This study by Antoine Gagnon-Poiré and colleagues entitled “Reconstructing past hydrology of eastern Canadian boreal catchments using clastic varved sediments and hydro-climatic modeling: 160 years of fluvial inflows” presents an interesting counterpart to rainfall-runoff modeling approaches that aim at expanding instrumental streamflow datasets for multi-decadal analysis of hydrological variability. Indeed, this study based on varved sediment sequences aims at producing long river discharge records (>100 years) to support, help refine or contradict paleo-hydrological records offered by the modeling approaches.

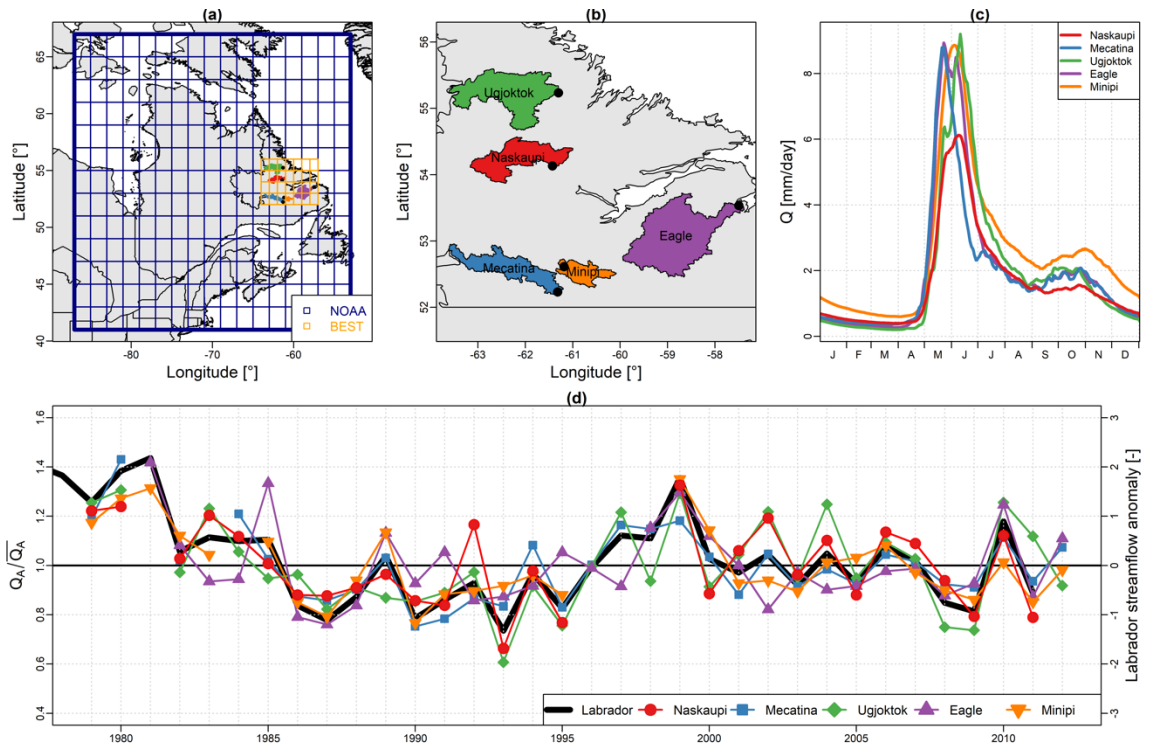
Variables Q vs SSC are always presented as a log-log linear regressions. The same should applied to DLT vs Q, likely to P99D0 vs Q. From the scatterplot presented in Fig 8, it is likely that the general proxy-hydrometric relation follows a $DLT=f(\log(Q))$, or a $\log(DLT)=f(\log(Q))$ relation rather than a linear relation. See Warrick (2015) and references therein, or Thurston et al. (2020). This should be tested as it has major implications on statistical yields in the sediment-hydrological relations.

Thank you for that comment and literatures. This will be tested.
